Traffic Impact Study

2024-10-03 (DJK) reviewed, comments include:

QuikTrip 4263

Aurora, Colorado

FIGURE 2
QUIKTRIP 4263
AURORA, COLORADO
EXISTING GEOMETRY AND CONTROL

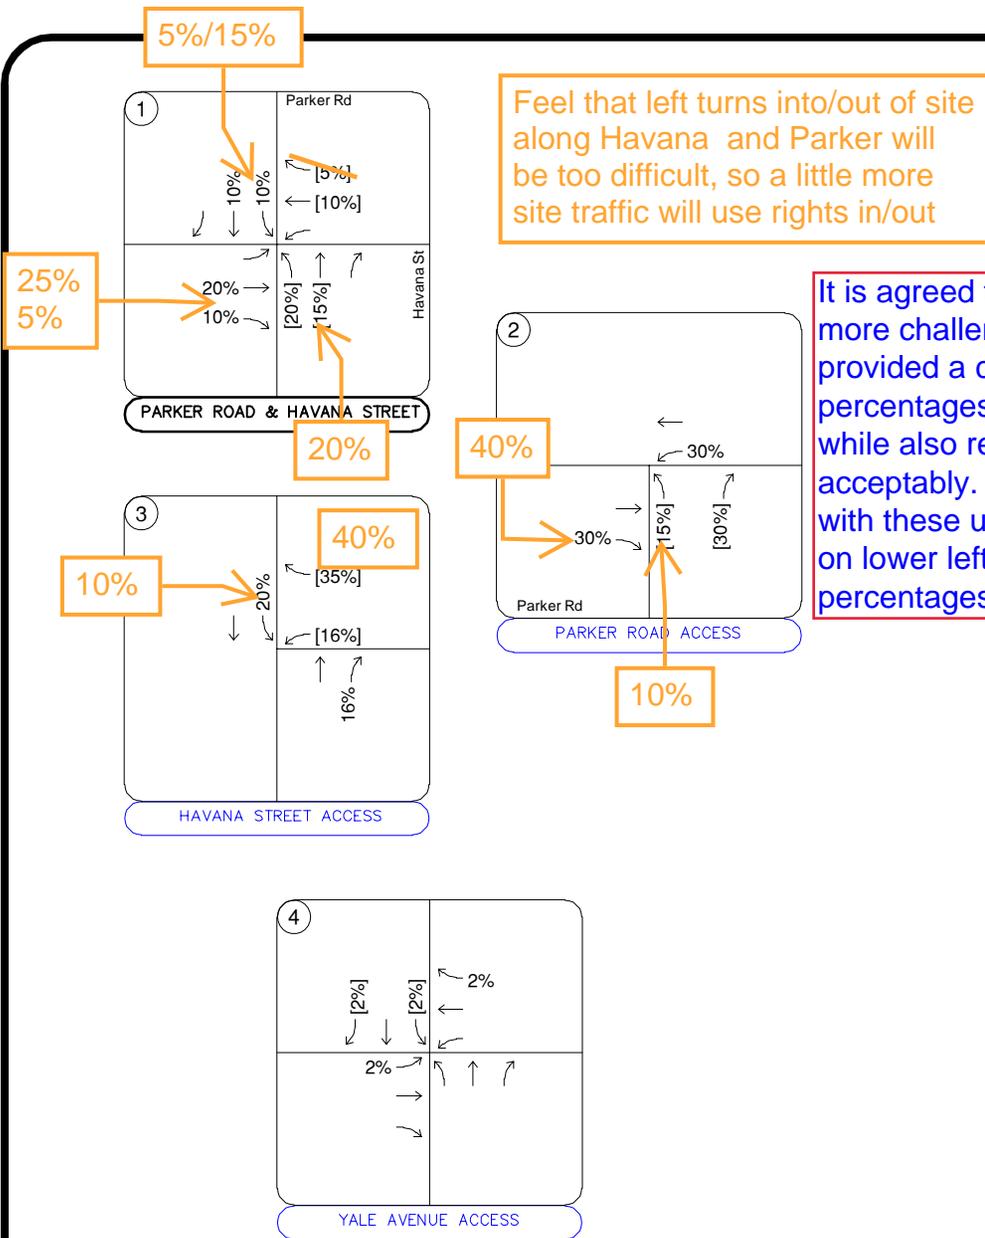
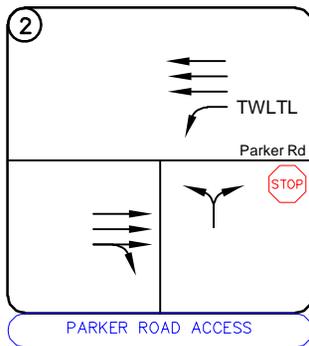
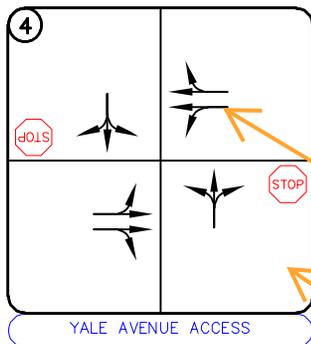
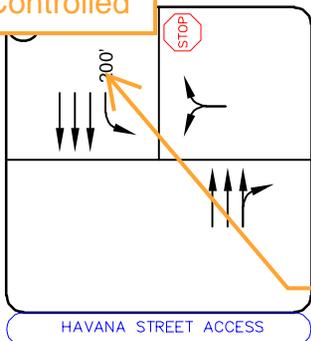
Lengths updated

free flow channelized (225') & right lane marked from 1300'

Yield Controlled

I only get 125' max

would call this a left turn only lane, 155' long

Technically then, there are three access points on Yale...

Channelized length of 225' (Accel) and continuous length of 1,300 has been identified.

Yield label added

Revised.

updated to a left turn (extension of the dropped left turn immediately to west) labeled with 155' feet of storage and one shared through/right turn lane

It is understood that three accesses are along Yale Avenue. This traffic study is only studying the accesses that would be utilized by this project. Therefore, labeling as one access is believed to be appropriate in this situation.

FIGURE 6
 QUIKTRIP 4263
 AURORA, COLORADO
 NON PASS-BY PROJECT TRIP DISTRIBUTION

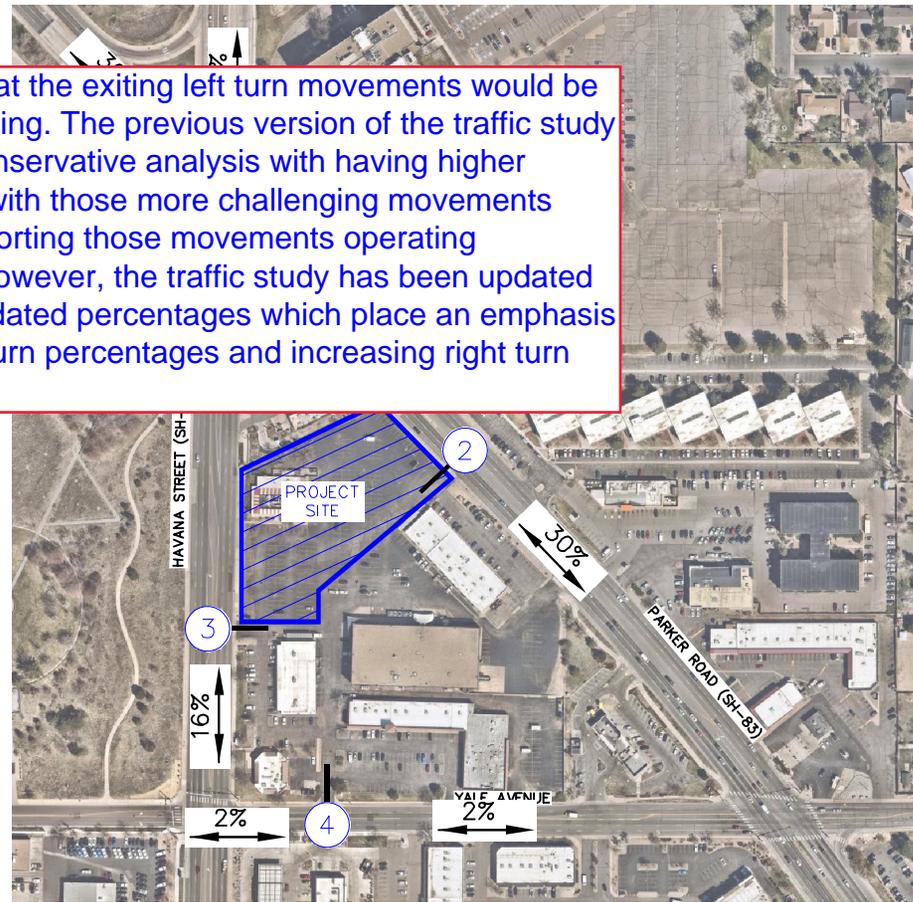
Feel that left turns into/out of site along Havana and Parker will be too difficult, so a little more site traffic will use rights in/out

It is agreed that the exiting left turn movements would be more challenging. The previous version of the traffic study provided a conservative analysis with having higher percentages with those more challenging movements while also reporting those movements operating acceptably. However, the traffic study has been updated with these updated percentages which place an emphasis on lower left turn percentages and increasing right turn percentages.

FIGURE 7
 QUIKTRIP 4263
 AURORA, COLORADO
 AM PASS-BY PROJECT TRIP DISTRIBUTION

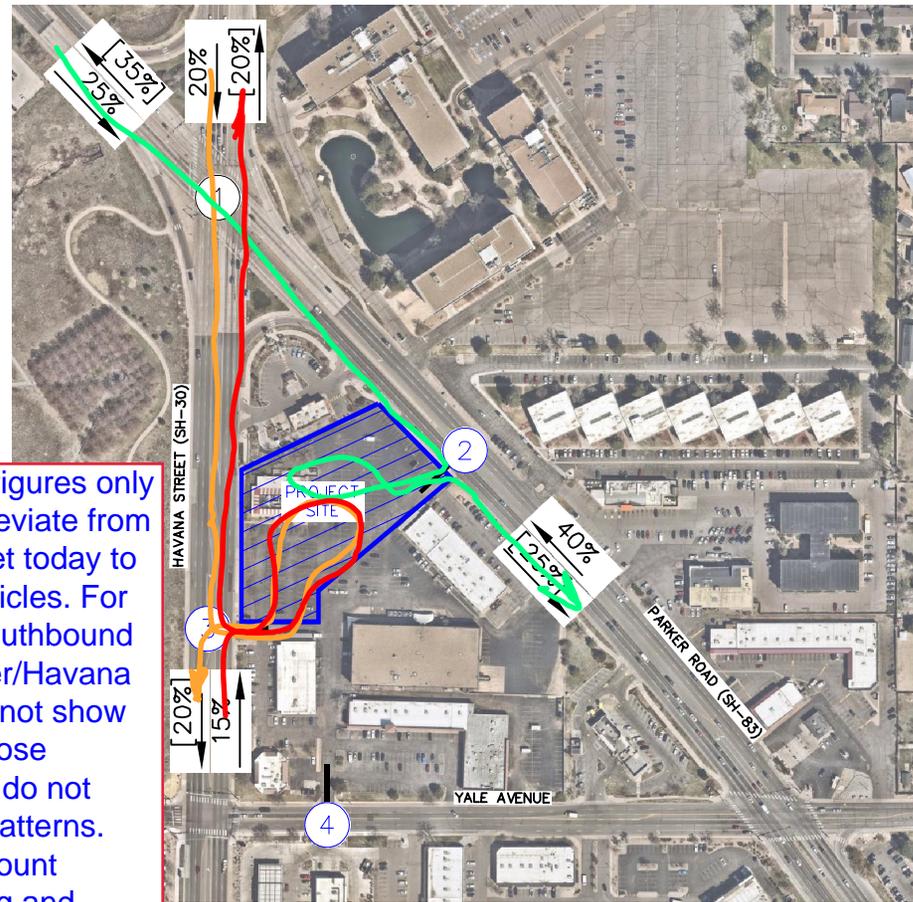
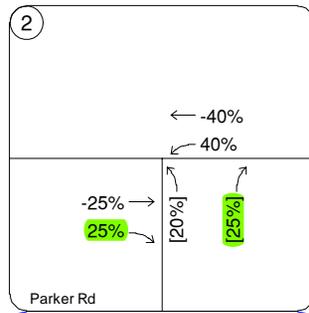
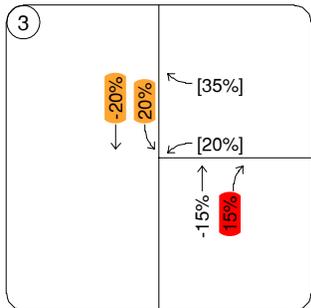
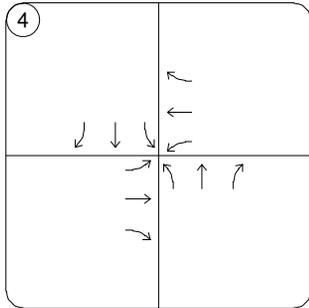
Sorry, can not follow pass-bys through and out of the site to the north, both peaks

Our pass-by trip distribution figures only show the percentages that deviate from existing volumes on the street today to avoid double counting of vehicles. For example, we have 20% of southbound through movements at Parker/Havana (Intersection #1) but they do not show up on the figures because those movements occur today and do not deviate from existing travel patterns. The trip distribution cordon count matches the external entering and exiting percentages.

FIGURE 11
 QUIKTRIP 4263
 AURORA, COLORADO
 2026 TOTAL TRAFFIC VOLUMES

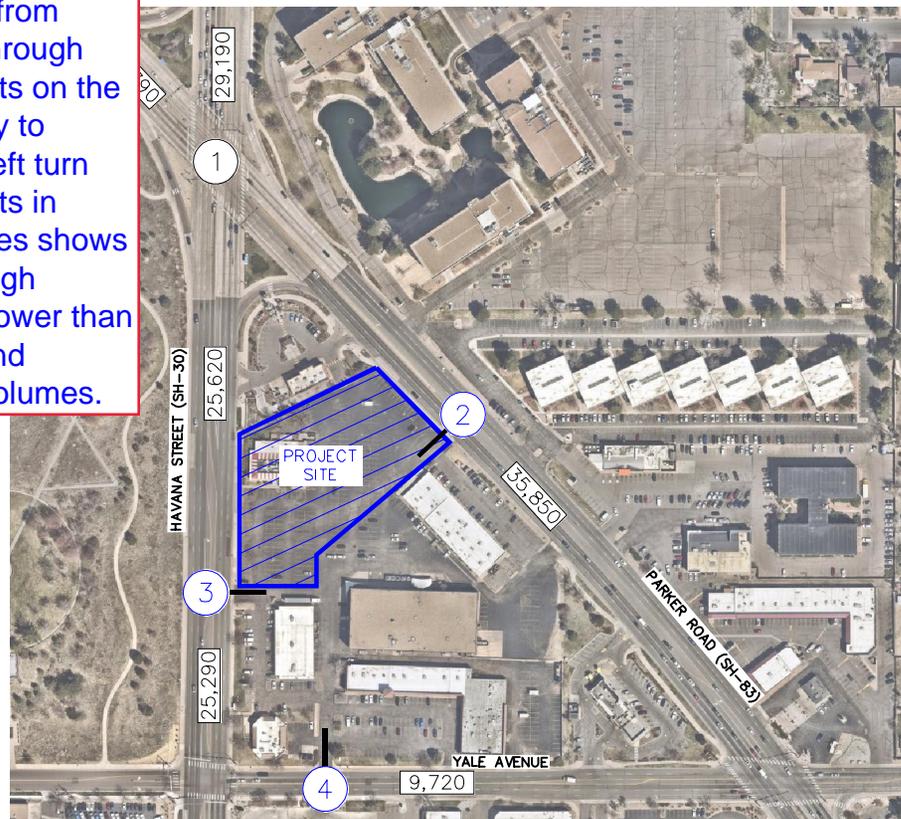
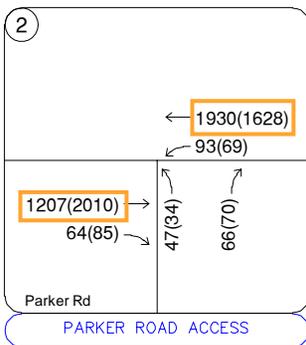
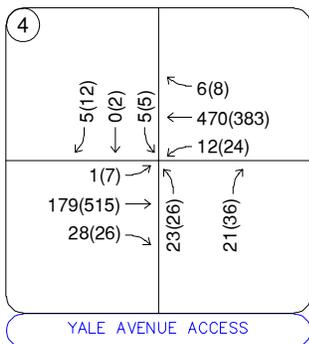
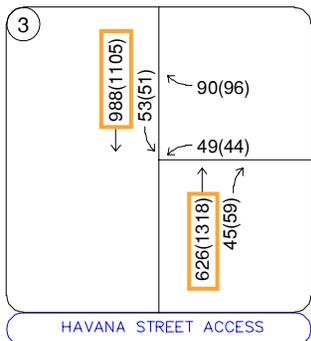
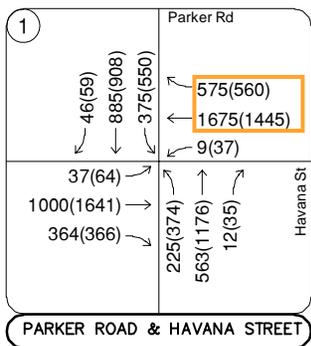
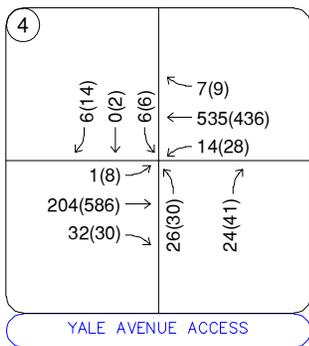
Less traffic than Background, due to redistributed pass-bys?

Correct, the pass-by percentages deviating from existing through movements on the road today to entering left turn movements in some cases shows total through volumes lower than background through volumes.

FIGURE 12
 QUIKTRIP 4263
 AURORA, COLORADO
 2050 TOTAL TRAFFIC VOLUMES

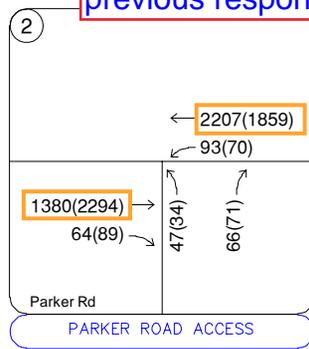
Same comment from 2026 Total

Please see previous response.

FIGURE 13
 QUIKTRIP 4263
 AURORA, COLORADO
 2026 RECOMMENDED GEOMETRY AND CONTROL

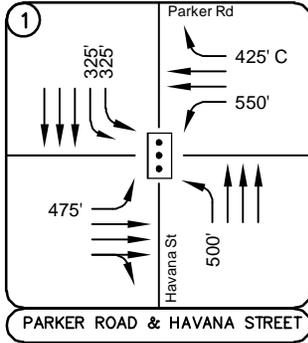
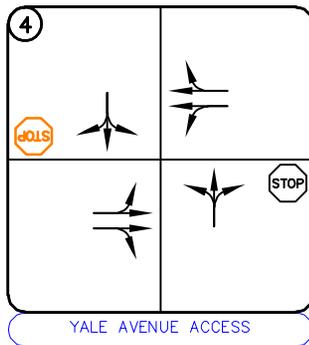
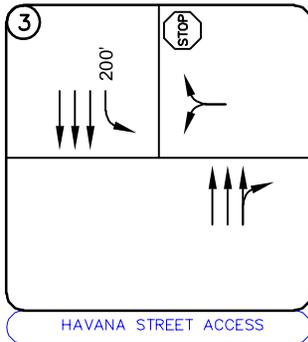
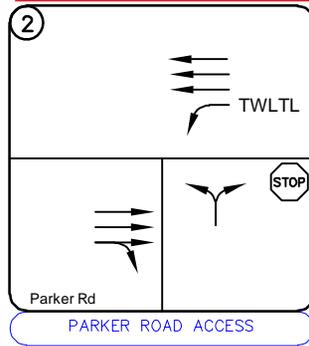
NB and SB Turn Lanes Prior to Intersection

Chk storage
from Fig 2

Updated based on
changes to Figure 2.

FIGURE 14
 QUIKTRIP 4263
 AURORA, COLORADO
 2050 RECOMMENDED GEOMETRY AND CONTROL

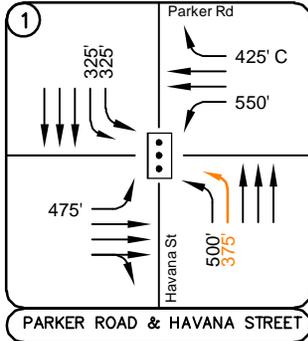
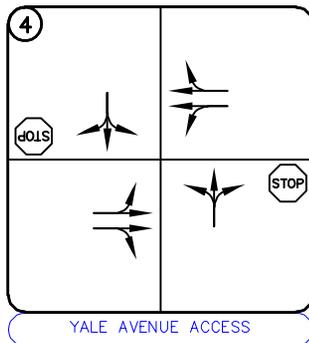
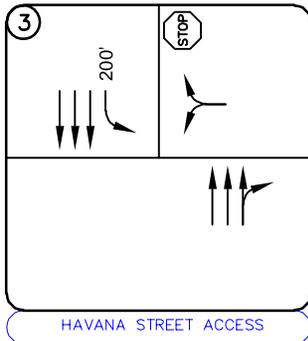
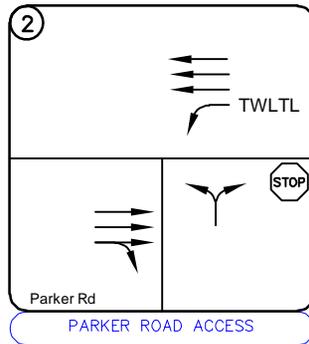
NB and SB Turn Lanes Prior to Intersection

Chk storage from Fig 2

Updated based on changes to Figure 2.

Note that CDOT could keep the existing lane configurations or implement NB dual left turn lanes operating lead/lag with the southbound left turn lane due to geometric constraints.
